Job No. 15-10937

Subject: **Addendum Geotechnical Report Response to City Reviewer
(Cycle 3) LDR Geology City of San Diego Project No. 669302
Dated August 28, 2020**
Lotus Residential Project
5064 Lotus Street
San Diego, California

City of San Diego, 2020, Cycle Issues LDR-Geology L64A-003A, dated August 28, 2020.

Figure No. II
Job No. 15-10937

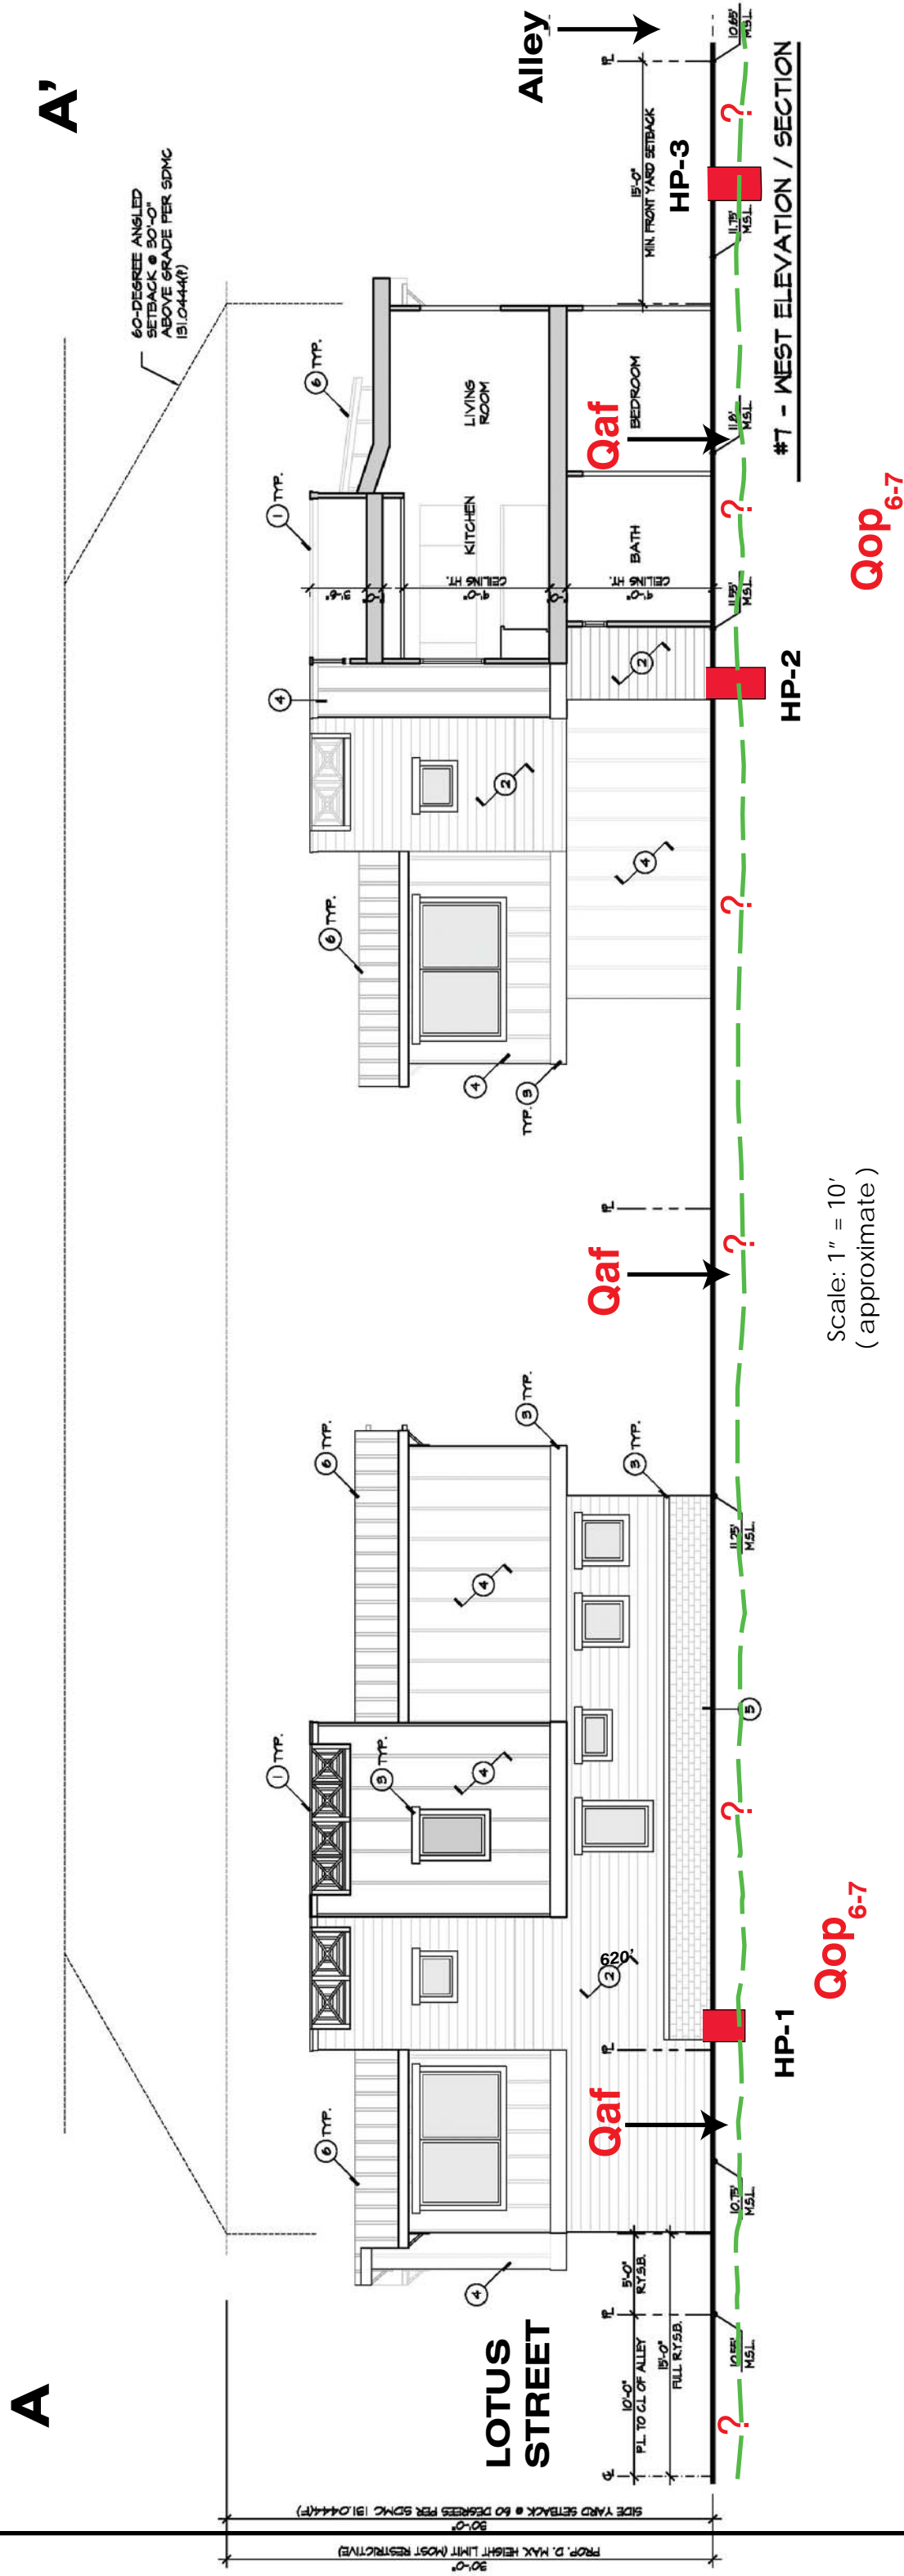
Comment No. 7: *Provide a geotechnical map on a topographic base that shows the geologic conditions, field explorations and proposed construction. Show the location of the cross section. (New Issue)*

GEI Response: Attached please find a geotechnical map on a topographic base that shows the geologic conditions, field explorations and proposed construction. The geotechnical map also presents the location of the cross section. The map is presented as an attachment (Figure No. II)

*Lotus Condominium Project
5064 Lotus Street
San Diego, CA.
Figure No. III
Job No. 15-10937*

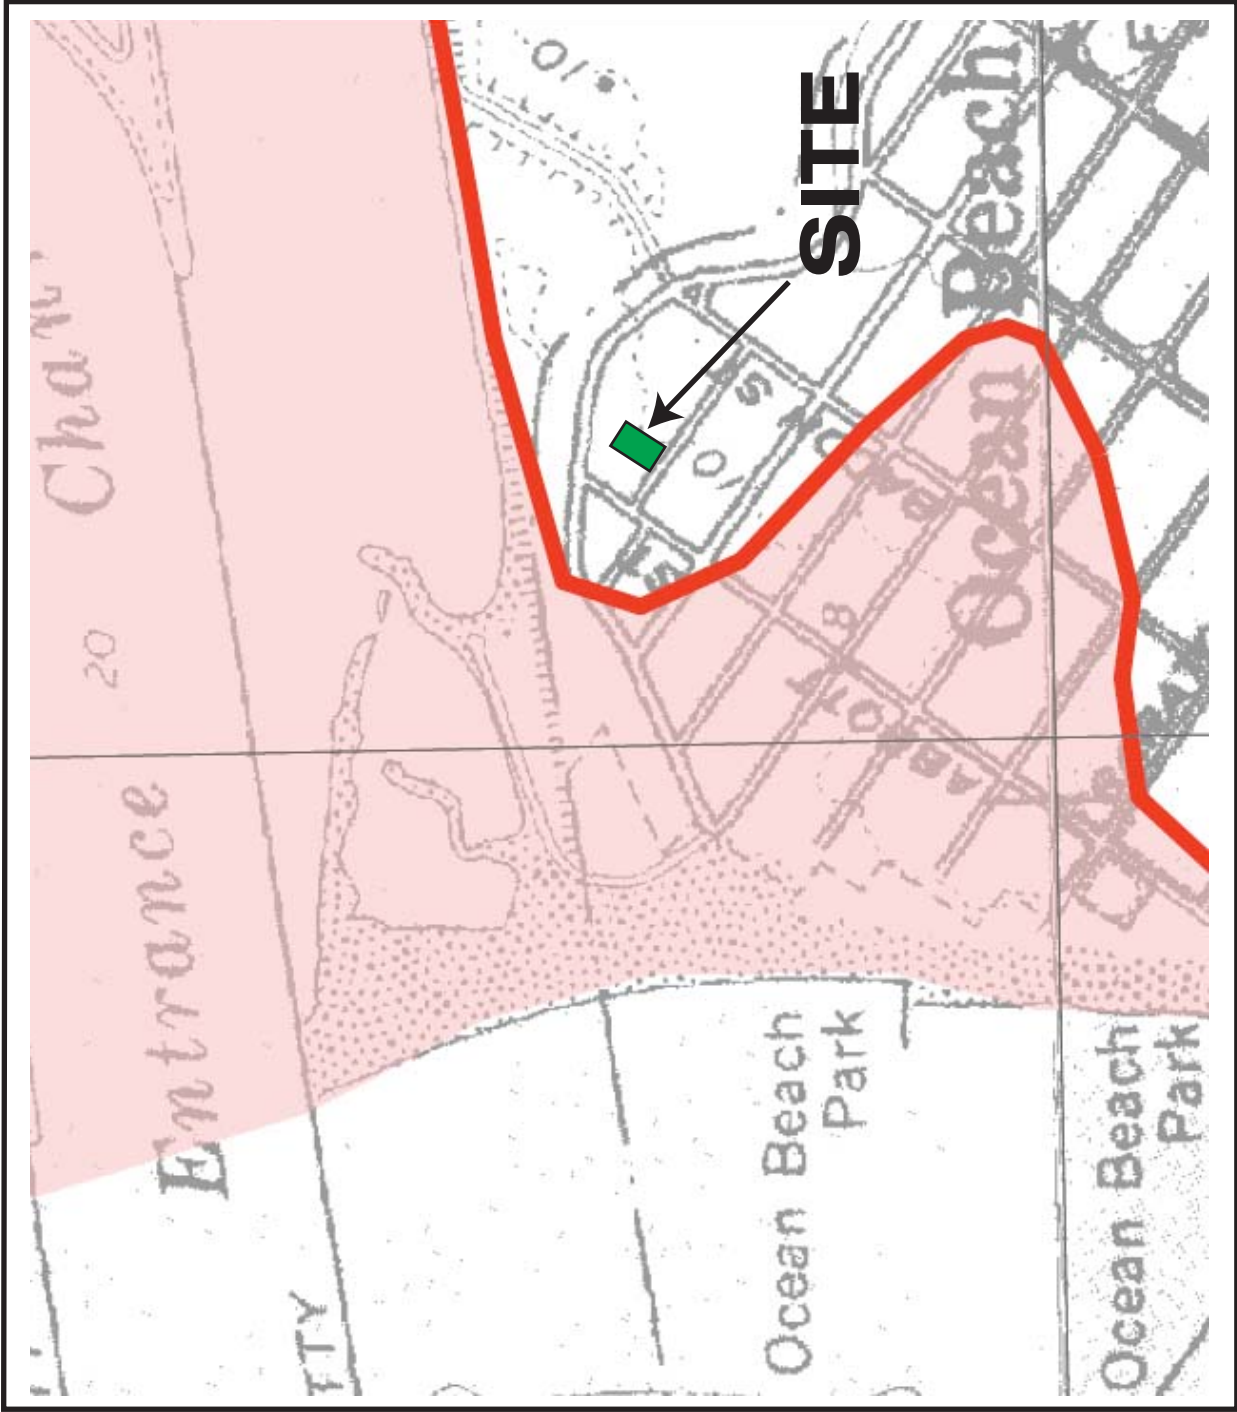
Comment No. 8: *Provide a geologic cross section. Depict the geologic/geotechnical conditions in relationship to the proposed development. Indicate maximum elevation of anticipated ground water. Refer to the City's "Guidelines for Geotechnical Reports" for the information typically shown on geologic cross.*

GEI Response: Attached please find a geologic cross-section (Figure No. III) presenting the geologic/geotechnical conditions in relationship to the proposed development. The cross-section also presents the depth possible groundwater level.

Review of the available references (GeoTracker) indicate that, at a site located approximately 500 feet southeast of the subject site and with ground elevations similar to those of the subject site, groundwater was encountered at a depth of approximately 14 feet below ground elevation on November 13, 2009. Although groundwater level in that area may fluctuate with tides, it is our opinion that it is a reasonable representation of the groundwater level for the general vicinity of the site.
